**TOTAL MAXIMUM DAILY LOAD (TMDL)
FOR THE
UPPER RIO GRANDE WATERSHED (PART 2)
COCHITI RESERVOIR TO PILAR, NM**

APRIL 12, 2005

**TOTAL MAXIMUM DAILY LOAD FOR TURBIDITY AND
SEDIMENTATION/SILTATION (STREAM BOTTOM DEPOSITS)
EMBUDO CREEK (RIO GRANDE TO CANADA DE OJO SARCO)**

Figure 6.2 Relationship between TSS and Turbidity for the Rio Grande (non-pueblo Santa Clara to Embudo Creek)

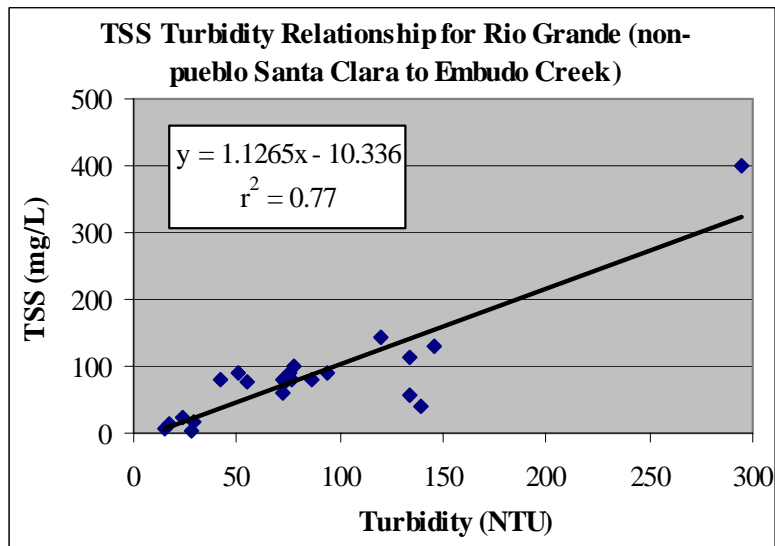
The Draft contains a table showing the total suspended sediment (“TSS”) and the NTUs for the stretch of the Rio Grande area in question. Draft at 6.1 (Table 6.2). Significantly, the table shows the upper Rio Grande exceeding 50 NTU 71% of the time. That fact alone can be seen as dispositive of whether the 50 NTU standard ought to be maintained. If under the natural condition, a norm would be violated three-quarters of the time, it makes little sense to establish the norm at 50 NTU. Suspending the 50 NTU standard would thus represent an acknowledgement of the reality of the natural condition along this stretch of the Rio Grande.

NMED/SWQB Response: Thank you for commenting. During the February 2004 triennial review of New Mexico's Water Quality Standards, NMED proposed changes to the turbidity standards to recognize varying background conditions. The WQCC approved these recommended changes. NMED is in the process of submitting proposed changes to EPA Region 6 for review and approval. Your comments have been forwarded to the SWQB Water Quality Standards Coordinator.
